# Sound Analysis Report on the Comparison of the Schneider Violin Bridge to that of a hand carved and tuned Maple Bridge of Standard design and shape. By: Dennis Boring 04/2012

Before trimming

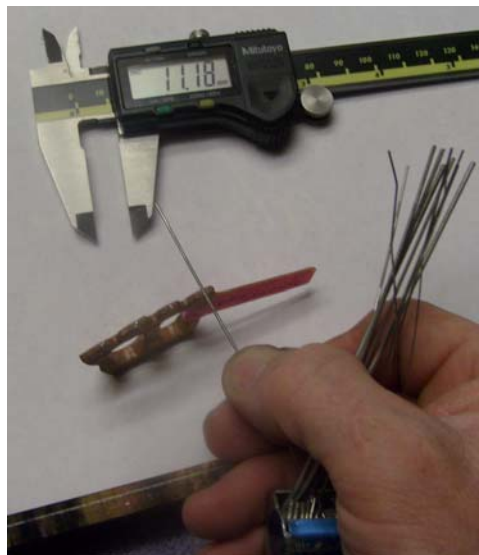
In an attempt to fit the one bridge that came tagged with handwritten words saying, “silver inside no contouring” I was needing to reduce the overall height of the bridge to somewhere close to my existing maple bridge since I require E string height of 3.5mm and a G string height of 5.5mm. In order to follow the instructions and ONLY remove material on the feet, I would’ve ended up with no bridge at all, having needed to cut up into the opening of the center. So... in an honest effort to give this bridge a fair analysis, I cut on the top as well, keeping the shape as sent to me but using a carbide burr and deepening the depressions between the strings and sanding the top of the bridge as required to lower the strings to a distance closer to what I needed. Although I was reluctant to cut anymore off the bridge, I was able to get my strings down to a height of 4mm and 6mm respectively.

Although it is obvious this would have affected the mechanics of sound transmission, there would be no other way to install this bridge so it had to be done. In an attempt to install it in the same location of my existing bridge, I attempted to 'swing' it up into position and deeply scratched the surface of the body from the harsh metallic content within the laminate. After removing the bridge I was able to refinish the affected areas with a combination of the 'French polish' procedure and a tiny bit of oil varnish diluted with 180 proof alcohol AND will wait about 3 days for it to cure before final polishing and reinstalling of my original maple bridge. The instructions said the end user should mix up some epoxy, spread it on the bottom of the feet and allow it to cure, then shape it to fit... etc. which is a complex job even for a luthier to accomplish and would add to the already high cost of the product making it prohibitive for most customers to even consider, and besides, the bridge was too tall already, and adding anything would make it too tall to even function properly.

**PEAKS & TRACES:**

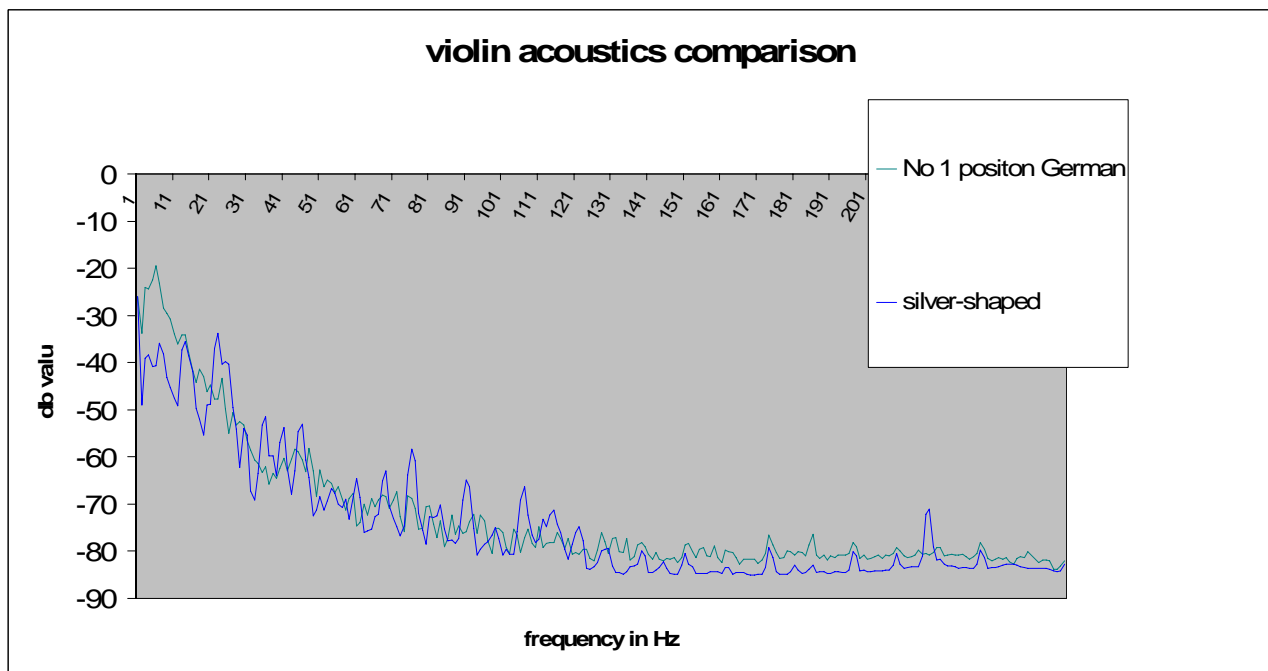
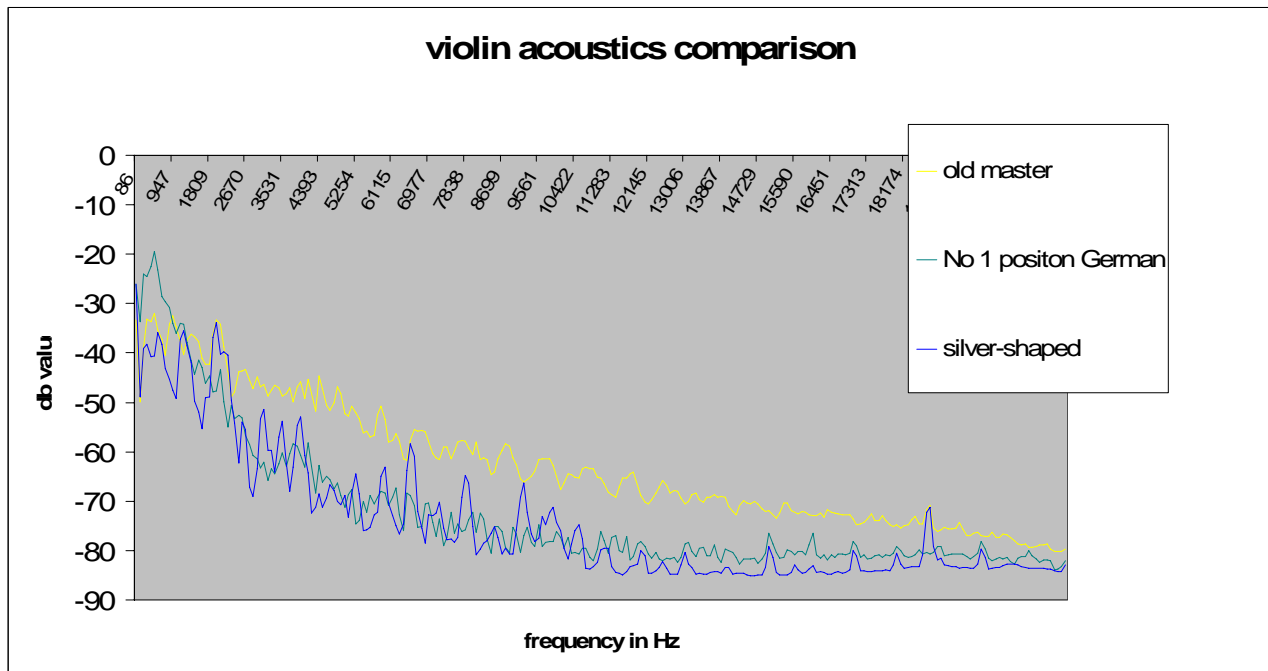
The trace labeled “No 1 position German” is the final position I achieved for the maple bridge and my sound sampling software analysis of my personal violin. Below is the same chart with the non-relevant traces suppressed. I left one “old master” trace for comparison. As you can see, the best sound I could achieve using a maple bridge is far better than the “silver – shaped” trace. Although throughout the entire spectrum the “silver – shaped” bridge “jumped all over”, it was far below the actual performance of the old school maple bridge. The trace was the best I could achieve with moving the bridge forward and back and still keeping it centered on the instrument. As you will notice in the lower frequencies, the lack of sound transmission was significant and with the slight exception of some occasional ‘peak’, was well below that of a well made maple bridge.

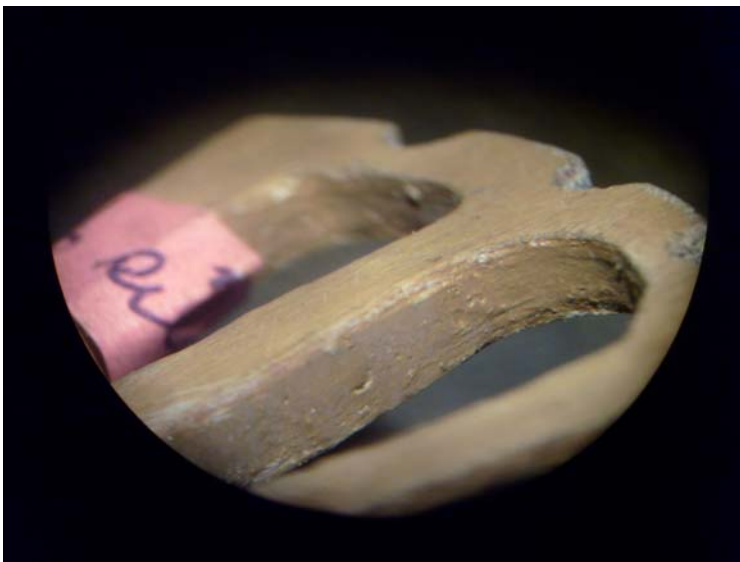
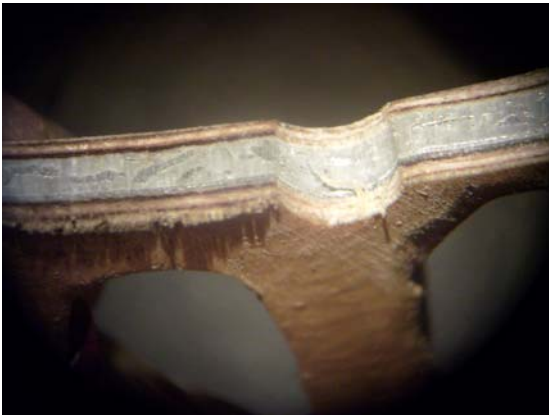
The inventor had sent 3 bridges for testing, but after examining them closer with a microscope, and then having such issues with the first one as scratching the violin severely, then the poor construction details, uneven surfaces, inconsistent openings, inconsistent mass, and poorly distributed flakes of silver colored metal particles in a resin mixture sandwiched between 2 small .042” thick plywood sheets, I chose to end this analysis since any data achieved beyond the initial plots shown above for initial curiosity would be meaningless in a controlled study except for that single one under study and the results will not apply to all bridges made by the inventor. Just because there’s a patent issued for a design, does not indicate an acceptable product per the claims.

The poor craftsmanship of all 3 of the samples would indicate a handmade and/or prototype appearance ...unworthy of retail sale at any cost. The inner surfaces were “painted by hand” with what I would suspect was an artists’ watercolor brush, the texture consistent with lumpy epoxy glue of tan color as show in the above photograph. This would also contribute to the lack of performance as suggested.

It is suggest that the designer look into the use of modern manufacturing techniques using laser, waterjet, and/or CNC processes and perhaps the use of molds and proper mixing machines to achieve a uniform recipe for the metallic/resin mixture and provide a method to prevent that metal compound from causing either string or instrument damage. The samples sent to me for analysis were exactly that... SAMPLES. In my opinion, without extensive tooling, assembly and packaging/marketing skills, this item is still in the prototype stage of development and is still a far ways from full retail production. If the use of modern manufacturing techniques and equipment were used and perhaps a professional facility, then the cost of manufacturing could easily be reduced to levels that will compete with current products. The estimated time to mfg one item in an assembly line environment can most likely approach a few minutes, instead of 2 hours as indicated by the inventor. The instruction sheet was poorly written, margins were minimal which made reading difficult and the font was all BOLD on the first and second pages with the use of all capital letters highlighting a ‘sales pitch’ style verbiage which lent no useful content to the ‘instructions’. Hand drawn sketches and the lack of photographs lent the air of ‘home made’ to the entire package and the lack of professional formatting also confirmed those suspicions.
